Central Coast Supplementary Local Planning Panel Business Paper 19 January 2022

2.1	Supplementary Report - DA/530/2019 - 2 & 11 Bryant Drive Tuggerah -	
	Mixed Use Development comprising Specialised Retail Premises,	
	Signage and Food and Drink Premises - (Agenda Item 4.1 Local Planning	
	Panel meeting 24 June 2021)	4

## Water Cycle Management Plan – Addendum Letter

Water Cycle Management Plan – Addendum Report Proposed Bulky Goods Development – Bryant Drive, Tuggerah (*Ref*: 190557)

The following two images show the cross section demonstrating increase in land height in the finger site section B - B (The first image is 2019 and the second is 2021).

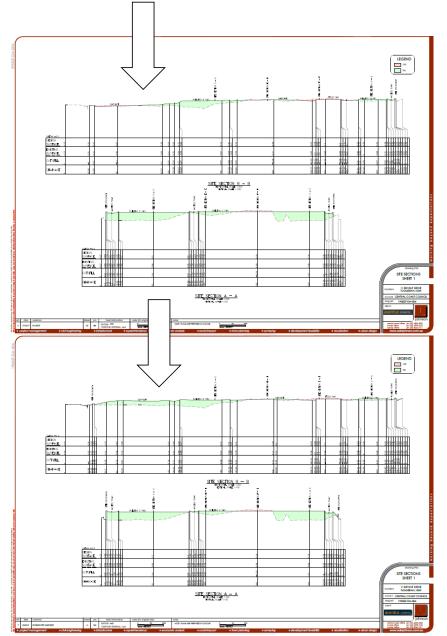
We would request that we be given the opportunity to discuss these issues with the relevant council experts. They need to stand here and envision a metre high retaining wall with a 2.1 metre fence on top along Eastern our boundary.

PROPOSED DESIGN DRAWINGS

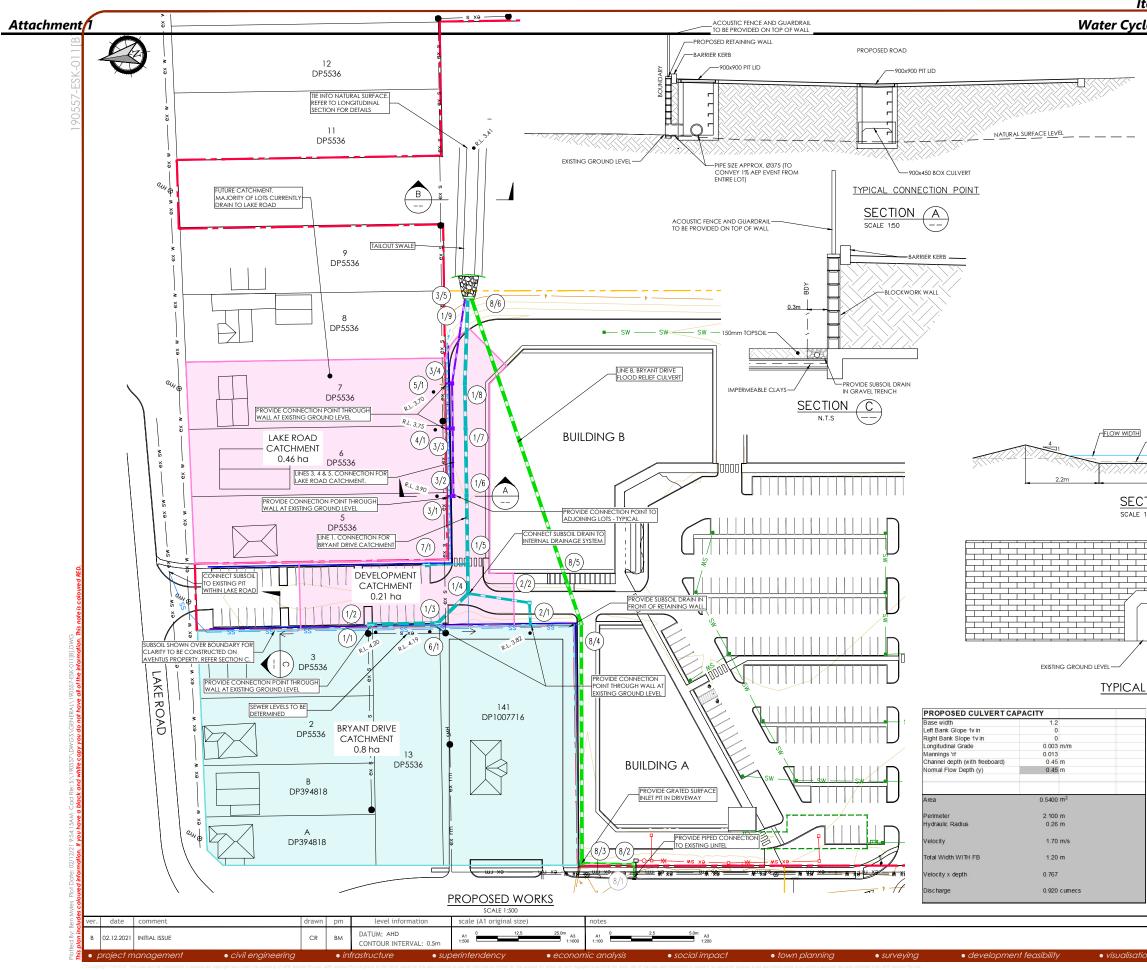
3. The images provided in the development application showing drains on the "finger" are misleading and definitely do not show drainage for the adjoining lots 3 (our house) and Lot 13 DP5536. All other adjoining properties have future drainage supplied but ours do not.

- The amended design is to address the filling of the drainage channel and either show that the filling of the channel has no impact on adjoining properties, or provide an alternate system to, at a minimum, match existing conditions (ideally improve existing conditions);
- Future and interim stormwater connection points are to be provided to all adjoining properties;
  - The connection points are to not increase inundation on the adjoining properties through backflow issues;
  - $_{\odot}$   $\,$  The system should consider capacity for around a 5% AEP event;
- The proposal is to ensure that natural flow paths, including groundwater are not blocked;
- The proposal is to consider the flow of water once the adjoining properties have been filled in accordance with the district stormwater Contributions Plan.

Despite this, the original proposal allowed for a connection to this property, however it is understood that this connection was not made clear. Accordingly, the design drawings have been amended to provide a clear connection point to allow overland flows to continue to drain east and to allow for future development in accordance with the district stormwater Contributions plan. Refer to Section 5.0 for details of the amended design.

It is noted that the filling of the "finger" is required under the Contributions plan strategy and therefore is required to allow for future development of the area. Once the adjoining properties are developed and filled (timing unknown), there will be no overland flow issue. To alleviate the potential impact during the interim scenario, the amended design provides connection points to all properties adjoining the Aventus site, including a subsoil drainage system.

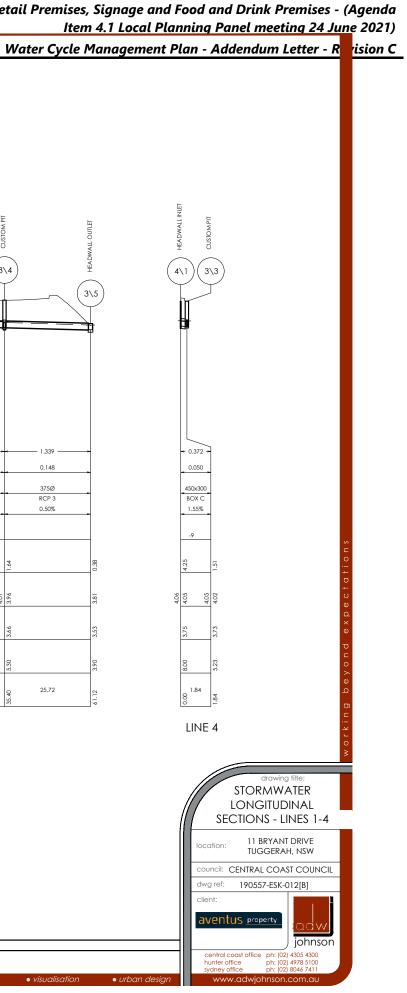
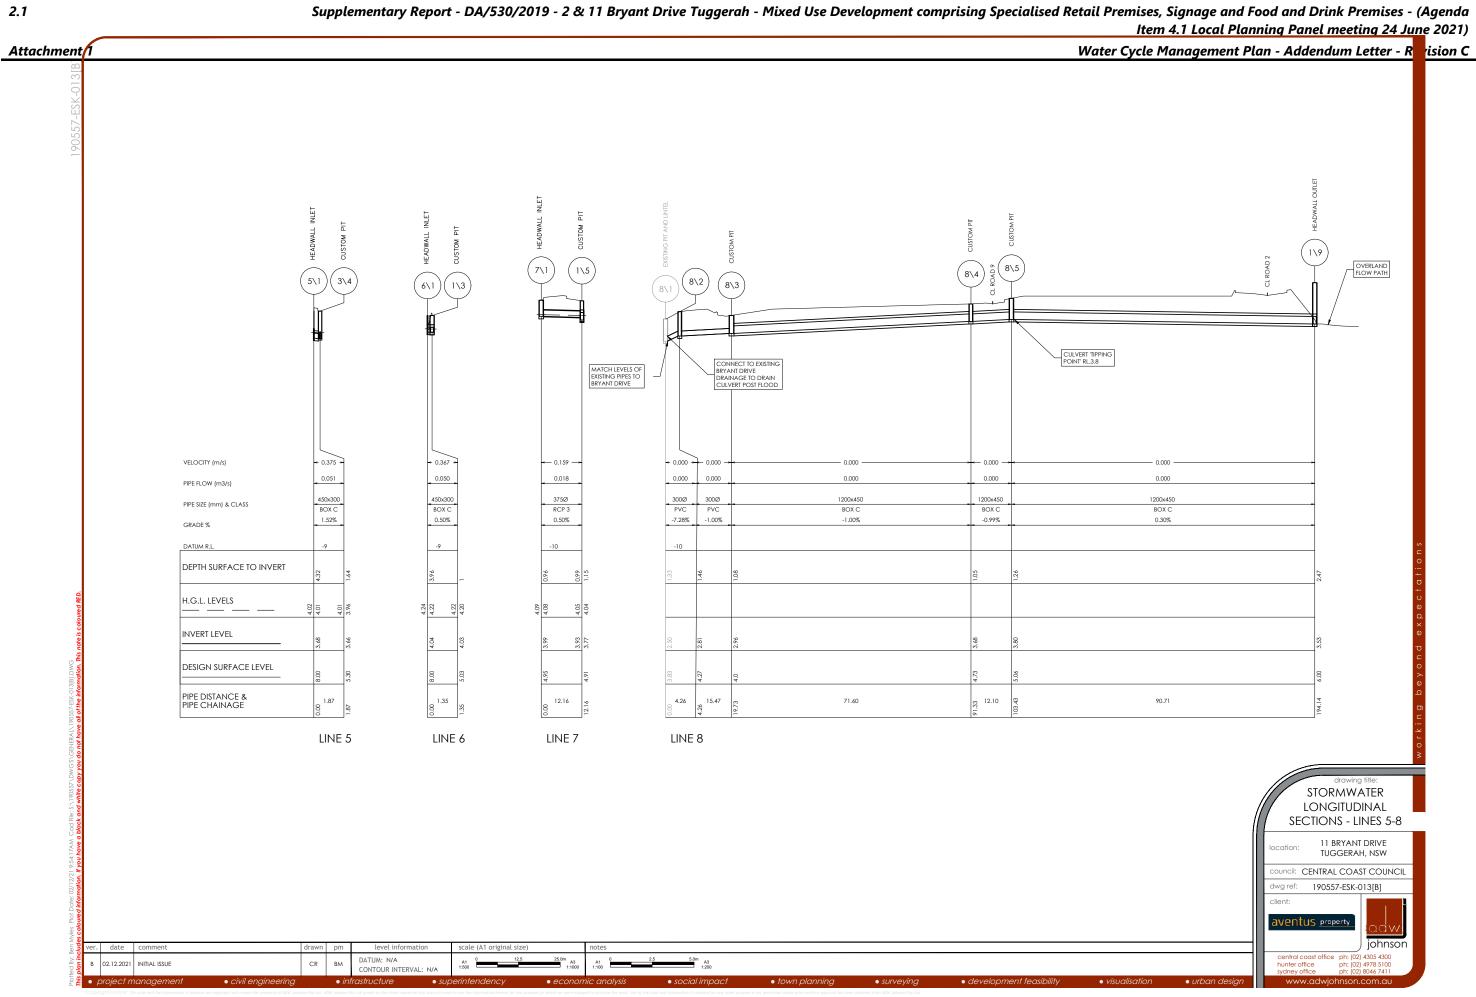
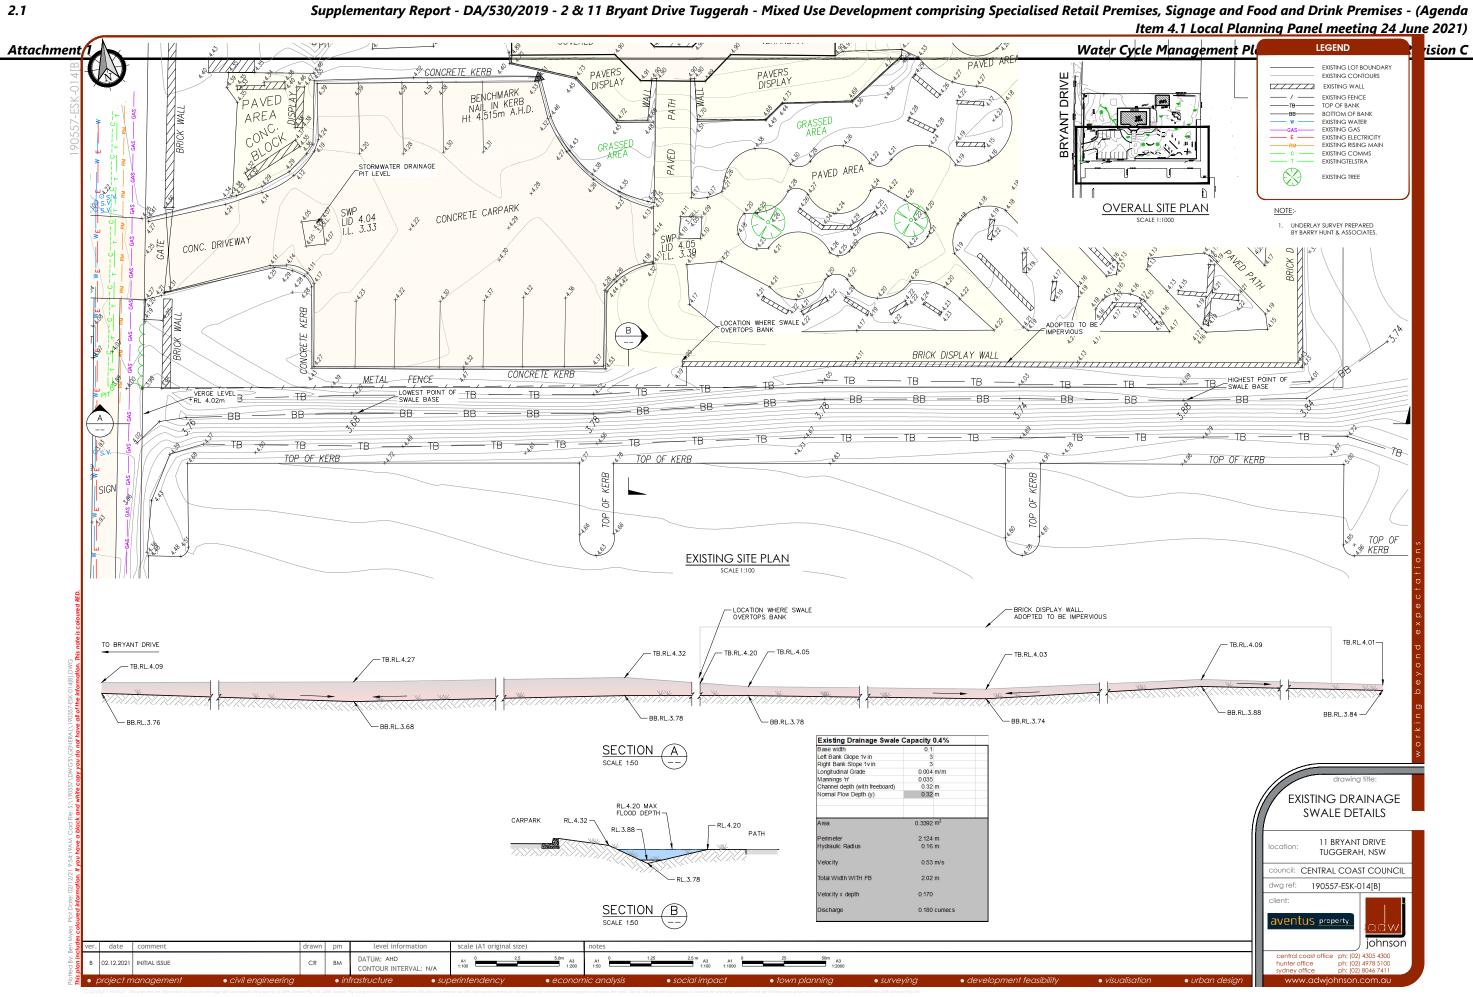
What the current application is proposing is to delete the existing drainage swale arrangement, fill the land and re-direct the overland flow from the Aventus land to Blueview's land (adjoining land)

- The amended design is to address the filling of the drainage channel and either show that the filling of the channel has no impact on adjoining properties or provide an alternate system to, at a minimum, match existing conditions (ideally improve existing conditions);
- The proposal is to ensure that natural flow paths are not blocked;
- The proposal is to consider the flow of water once the adjoining properties have been filled in accordance with the district plan.

Despite the above, ADW Johnson proposes to amend the proposed design to provide a flood relief culvert that improves the existing flooding of the adjoining property.

Despite the flood RL provided by Council indicating that in storm events up to and including the 1% AEP event flows within Bryant Drive would not overtop the verge level, it is proposed to provide a new flood relief culvert adjacent to the existing low point to exceed the capacity of the existing drainage swale. Details of this design are provided within section 5.0.

- Flood culvert to convey any flows overtopping Bryant Drive in extreme events;
- Stormwater connection points to adjoining properties;
  - This system is split into two (2) systems to convey the Bryant Drive and Lake Road lots separately (refer Section 5.3 for details);
  - This system was designed to cater for both the future development in accordance with the district stormwater Contributions Plan and the interim scenario to avoid blocking natural flow paths.

Figure 8: Extract of the contributions plan showing Figure 16 (drainage strategy)

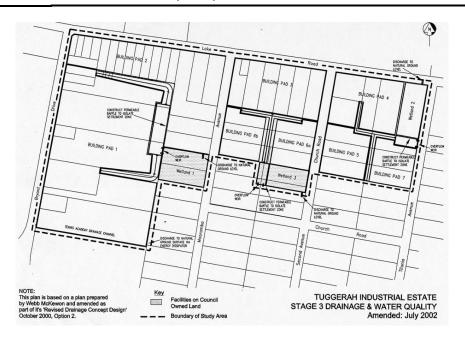
The current adopted drainage strategy for the area is identified in Figure 16 from Wyong District Development Contributions Plan. Stormwater for this catchment is to be directed to the east, via stormwater management / water quality facilities. The contributions plan includes the provision of drainage over the site.

Figure 9: Plan showing drainage strategy as it applies to the site in accordance with the contributions plan

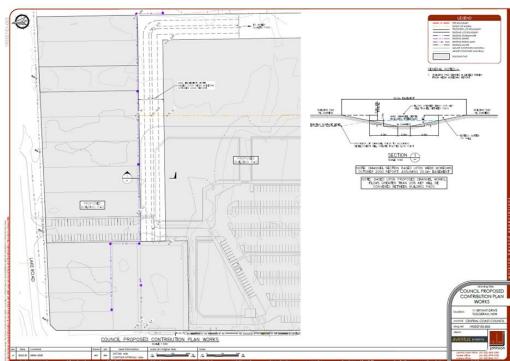
The drainage scheme adopted by the contributions plan requires an open drainage channel. The plan is informed by the Tuggerah Station Industrial Area Revised Drainage Concept Design prepared by Webb McKeown & Associates dated October 2000 Technical Report 1991 Tuggerah Industrial Area Stage 3 )ct 2000)- Tuggerah Area Drainage Concept Report (Webb McKeown) Oct 2000 - Flooding Engineers Report Nov 2000 - Land Valuation (SVO) Oct 2000 -D11699645:

#### Figure 10: Plan showing drainage strategy proposed by applicant (variation to the contributions plan)

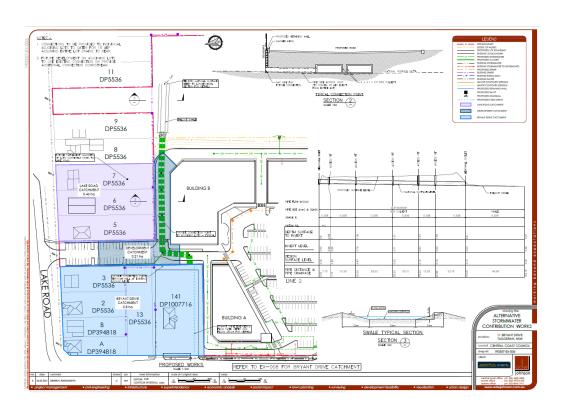
The applicant has proposed an alternative drainage scheme to that identified within the Wyong District Development Contributions Plan. The applicant has proposed a boxed culvert system that is informed by their Water Cycle Management Plan prepared by ADW Revision E dated March 2021.
